# 5 & 9 CULVERSTON ROAD, MINTO

Modification Report

This Modification Report has been prepared on behalf of Charter Hall Holdings Pty Ltd (**Charter Hall**) in support of an application to modify development consent SSD-7500 Modification 1 (**MOD1**) for warehouse and distribution uses at 5 and 9 Culverston Road, Minto.

Figure 4 Proposed site plan

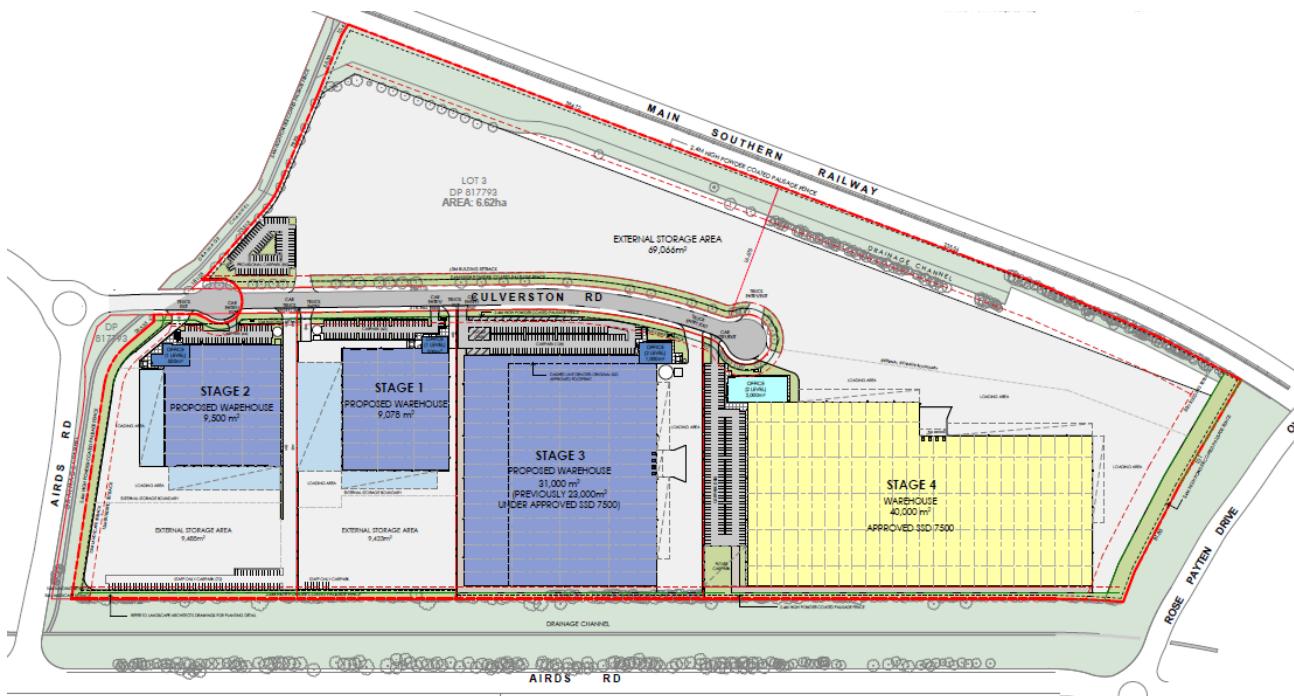
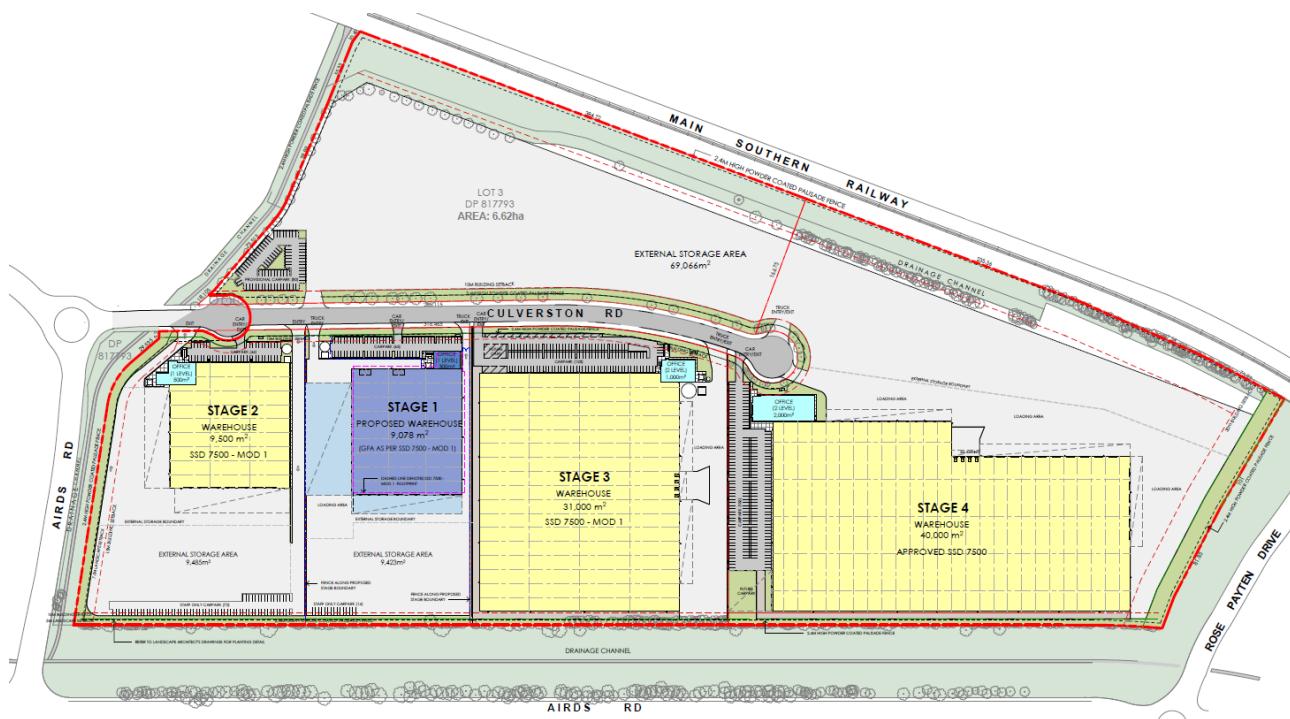
This Modification Application seeks changes to the plans and conditions associated with SSD-7500 MOD1. The future tenant of Stage 1 has progressed the detailed design for their warehouse and requires minor modifications to the approved plans including:

- Relocation of the car park access point from Culverston Road north by 41.95 metres.
- Relocation of the warehouse westwards by 2 metres and the office eastwards by 2 metres (no change to warehouse or office gross floor area).
- Relocation of the retaining wall to the car park westwards by 0.5 metres.
- Extension of the western warehouse awning to the south by 9.6 metres.
- Adjustment of the warehouse roof pitch from 2.5 to 3 degrees (no change to overall building height).
- Inter-tenancy boundary fence specification amended to cyclone fencing.
- Repositioning of loading dock roller shutter doors on northern and western warehouse elevations.

Minor modifications are also proposed to align the staging boundaries with the tenancy boundaries, including the ongoing activities to the south. This will require the southern boundary for Stage 1 to be 1.94 metres further north, also requiring the approved warehouse building and northern building in Stage 1 to move 1.94 metres to the north. The width of the southern vehicle access driveway in Stage 2 will be reduced by 1.94 metres to accommodate the amended boundaries. The proposed changes are shown in the plan extracts held as **Figure 4** and **Figure 5**.

Figure 5 Proposed Stage 1 modification plan mark up

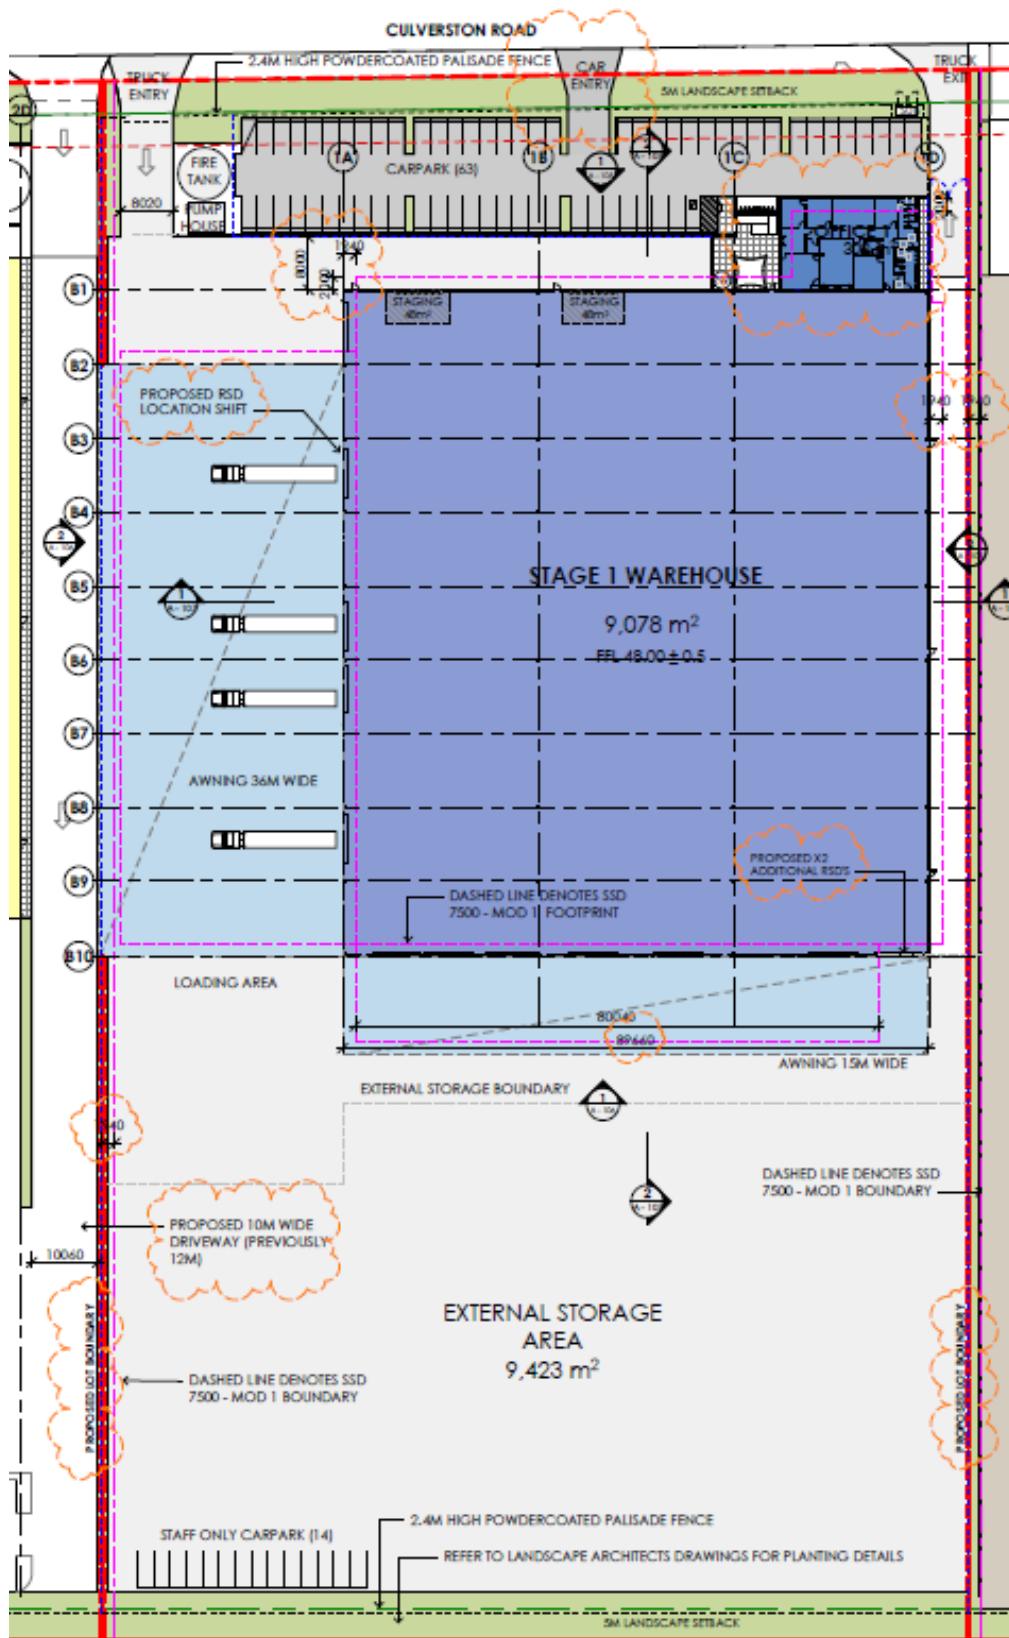
A correction is also proposed to be made to the approved car parking layout for Stage 1. SSD-7500 MOD1 approved 77 car parking spaces for the Stage 1 site, with 63 in the eastern car park and 14 spaces at the western boundary. Approved drawings 'A-04\_C Site Masterplan – Stage 1, 2, 3 & 4' and 'A-101\_D Stage 1 – Site Plan' incorrectly show 8 and 9 car parking spaces at the Stage 1 western boundary respectively. The proposed modified plans correct this to show 14 car parking spaces at the western boundary. This makes no change to the approved number of car parking spaces on site.

Figure 6 Proposed Stage 1 elevations

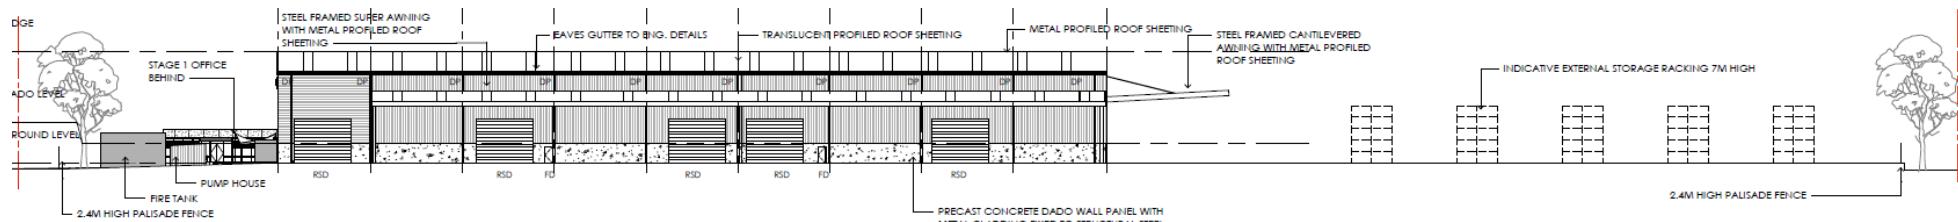
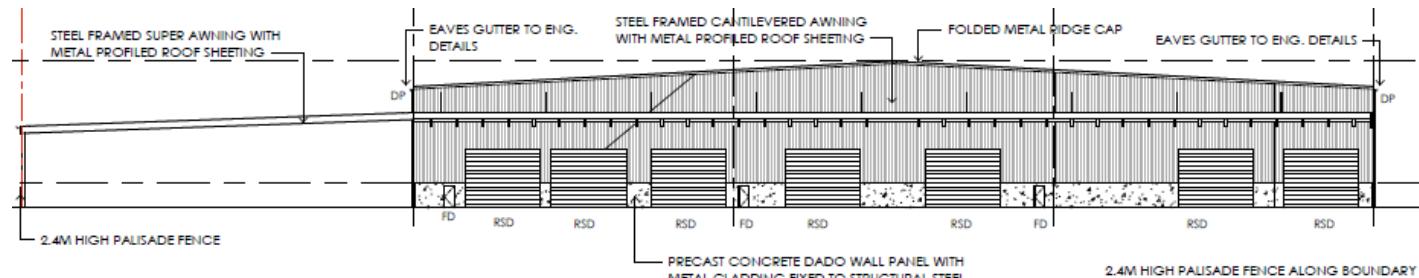
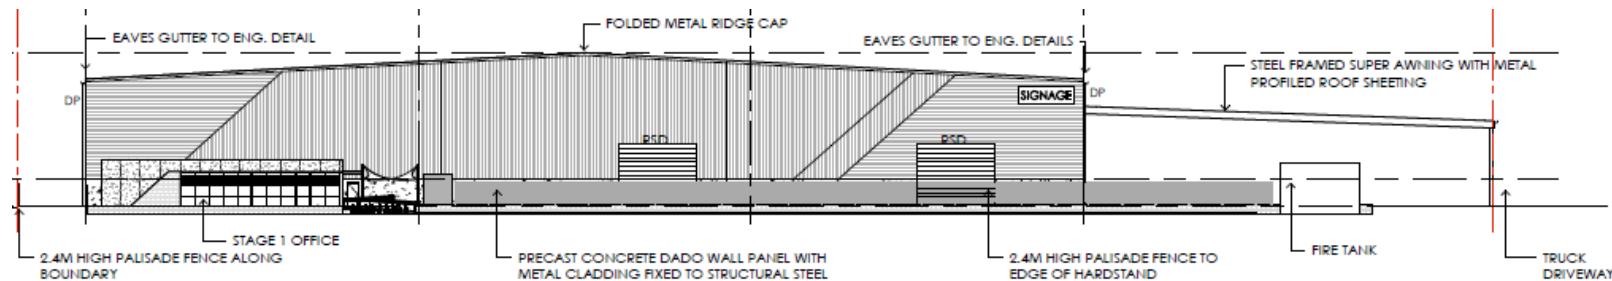
- Adjustment of the Stage 1 warehouse roof pitch from 2.5 to 3 degrees (no change to overall building height).
- Stage 1 inter-tenancy boundary fence specification amended to cyclone fencing.

The proposed modification does not make any change to the approved warehouse materials and finishes.
